# REGIONAL REVIEW FINDING

ARC REVIEW CODE: R1301021

**Name of Proposal:** Ponce City Market (formerly Ponce Park)

**SUBJECT:** **Transportation Division Review of DRI # 2318**

SAP SITE PLAN  
1"=30'  
1 OF 2  
SPECIAL ADMINISTRATIVE PERMIT

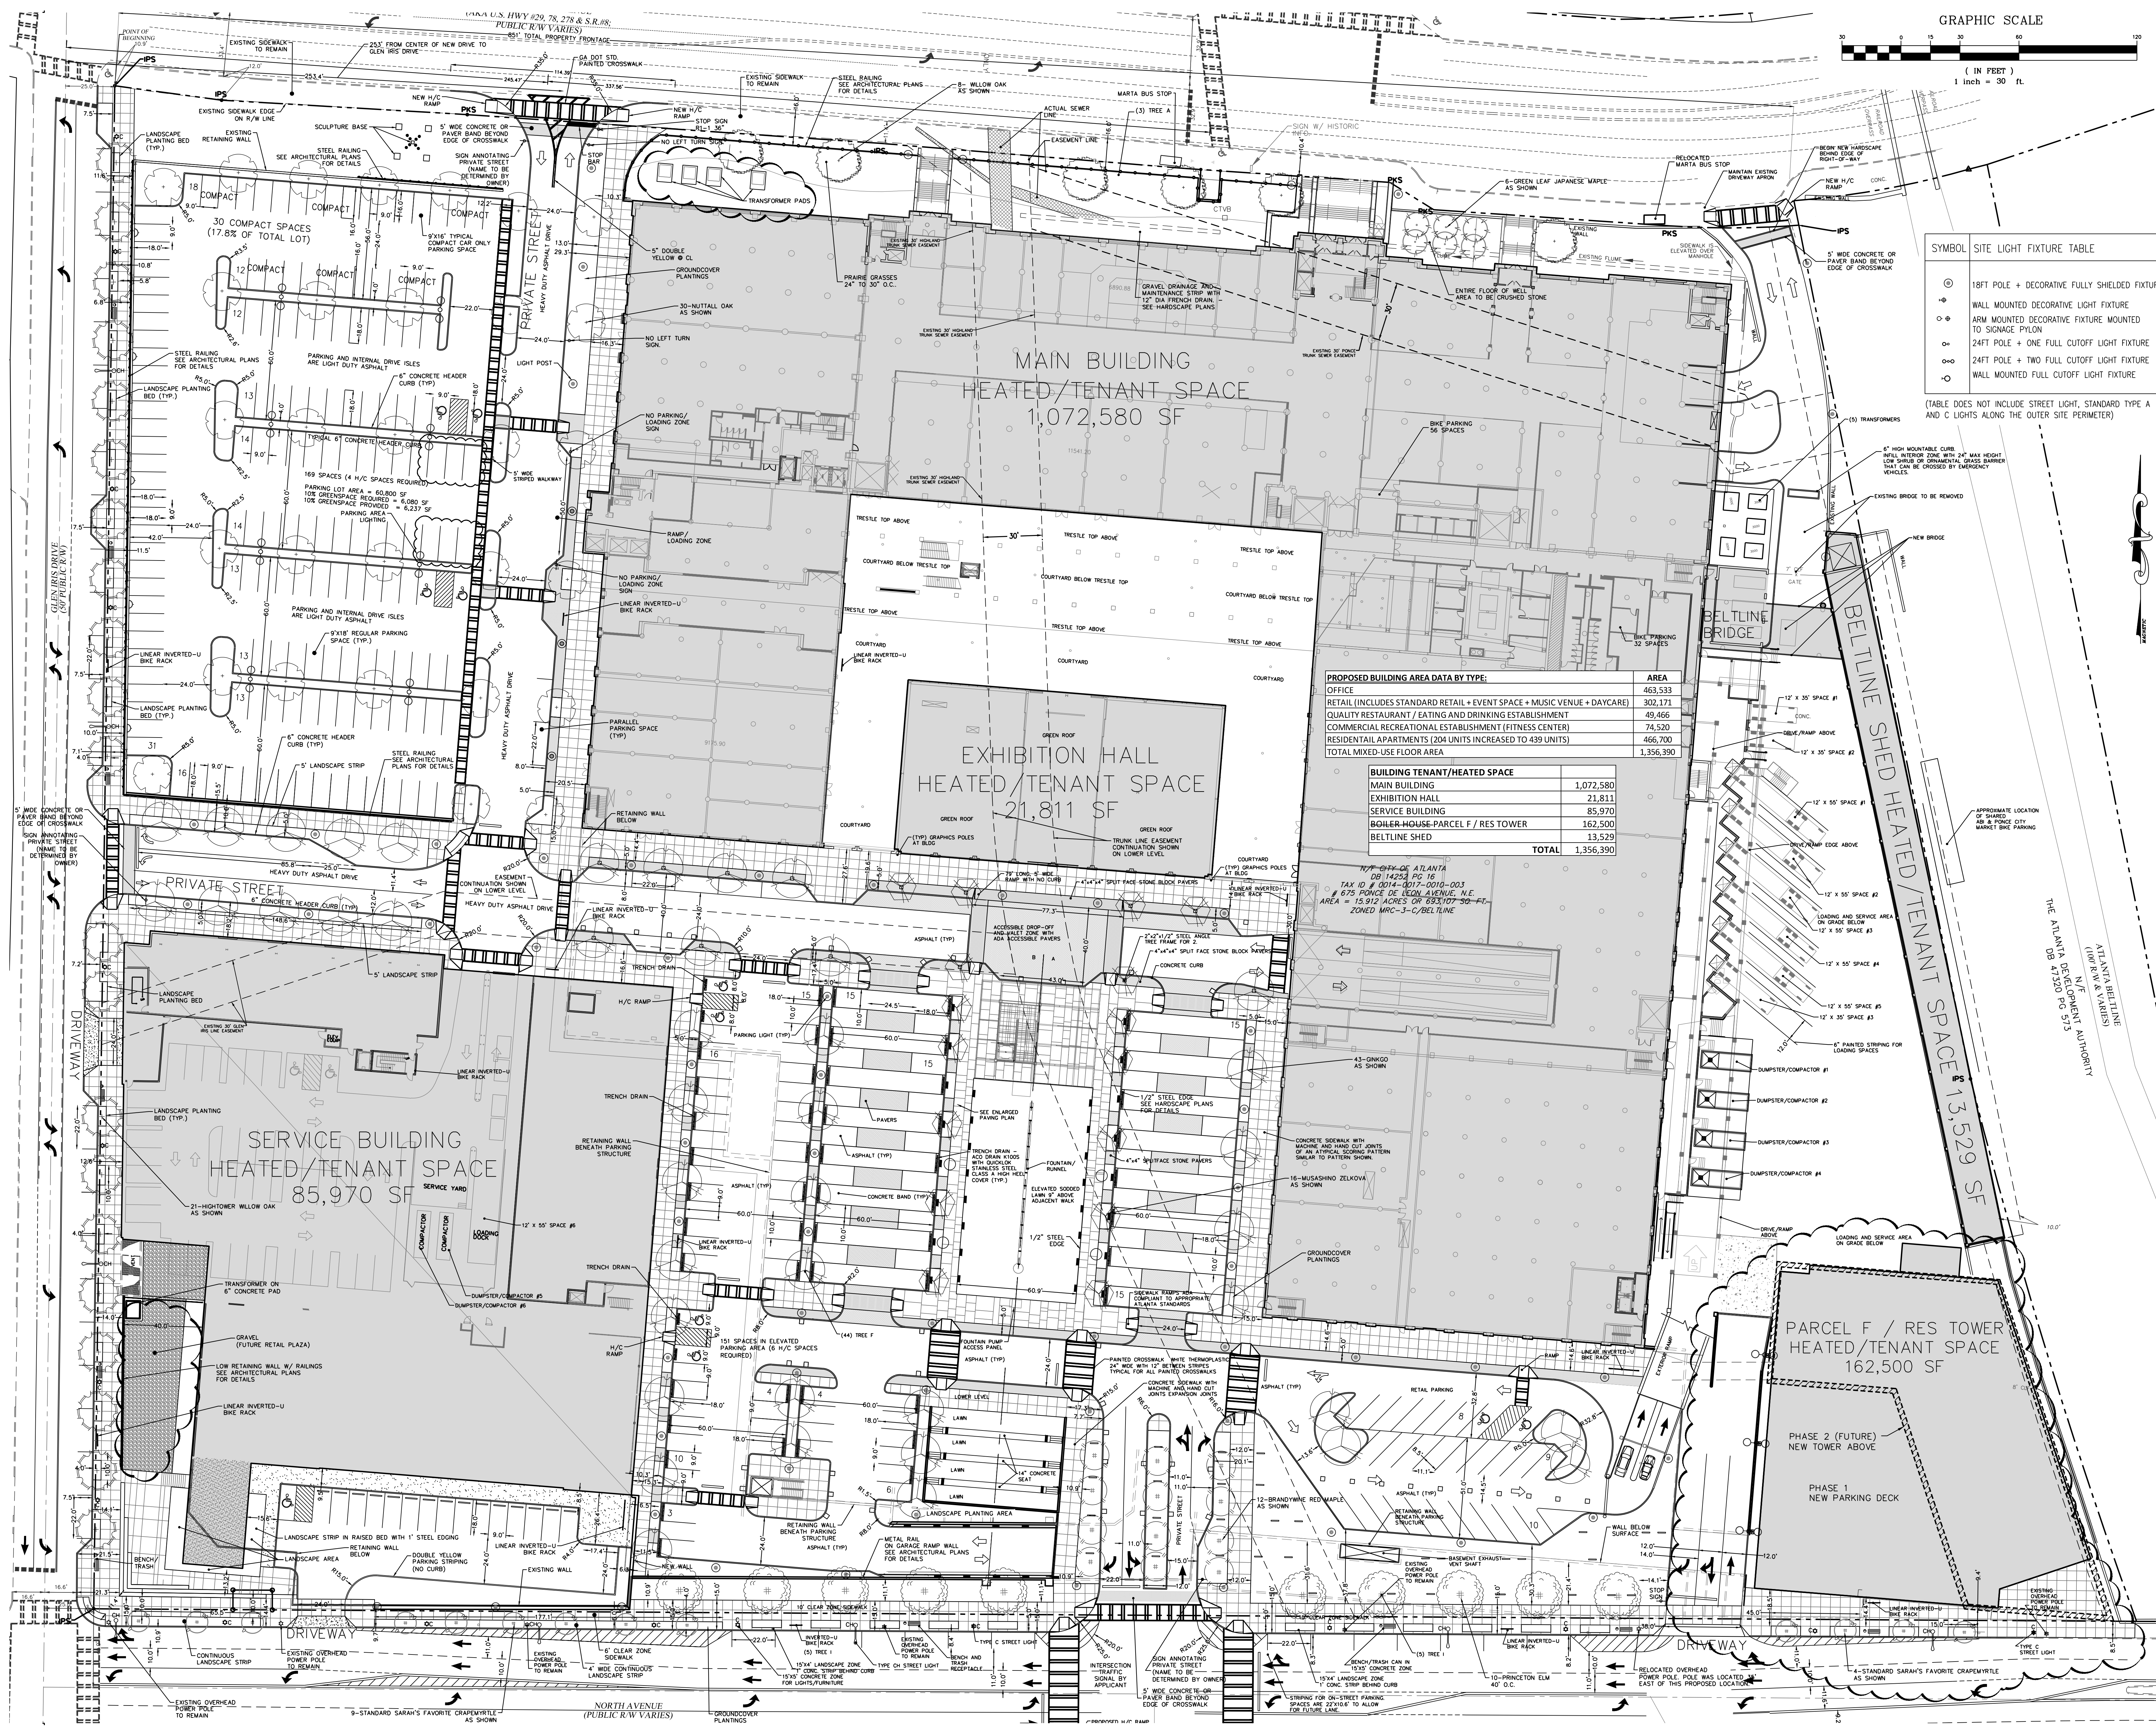
- We anticipate conflict on Glen Iris Drive, between the carwash and the entrance labeled Street #2 on the site plan, particularly on weekends when the weather is nice, which will likely see concurrent spikes in the number of trips made to both the carwash and PCM. Consideration should be taken to study how an island located in the turn lane between Ponce de Leon Avenue and Street #2 could prevent problems that may arise in the center turn lane. Additional improvements may need to be explored in order to ensure safe and easy access/egress along this section of Glen Iris Drive.

- During the pre-review meeting the applicant discussed a potential childcare facility located in the building labeled as Service Building in the site plan. The applicant should consider "kiss and ride" short-term parking spaces along Street #2, beside the Service Building, to prevent traffic from backing up at this entrance and to help maintain traffic flow on Glen Iris Drive.

- There needs to be careful attention to the design of Driveway #1. There are sightline restrictions for vehicles exiting the site via Driveway #1 due to the overpass and the westbound downgrade along Ponce to the east of the driveway intersection. Consider a right-in, right-out driveway in order to prevent congestion and improve safety arising from possible left turn movements to and from Ponce de Leon.
